SPYDER RT 2021 Storage Panel Rework Needed - 139442

These 2 rear storage panels will need some minor rework if replaced on MY21 RT.

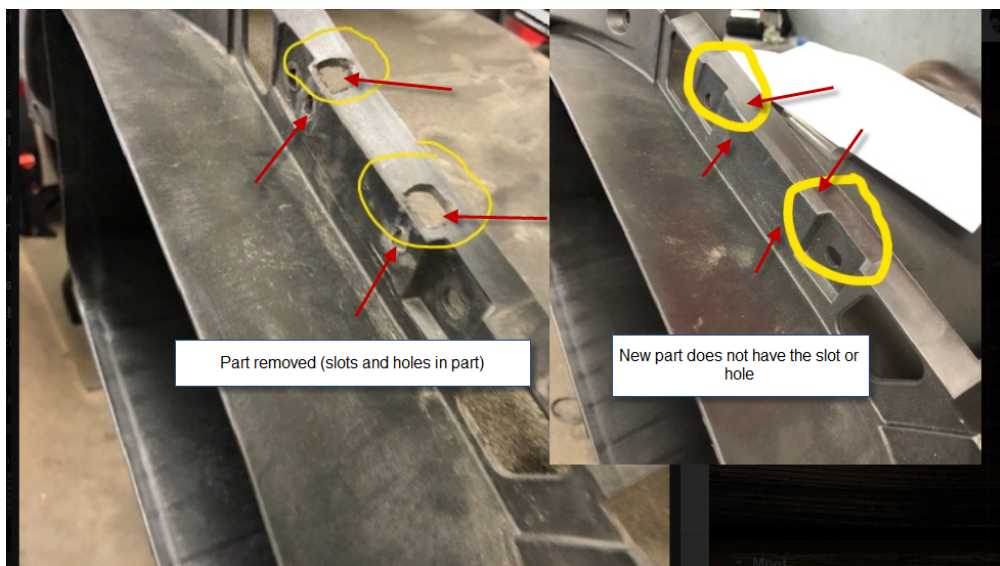
If ever you have to replace a rear saddlebag 708303846 or 708303847, some minor rework will be necessary. Two holes are missing for the retaining clamps.

The templates to rework the rear storage box according to the production vehicle are attached below.
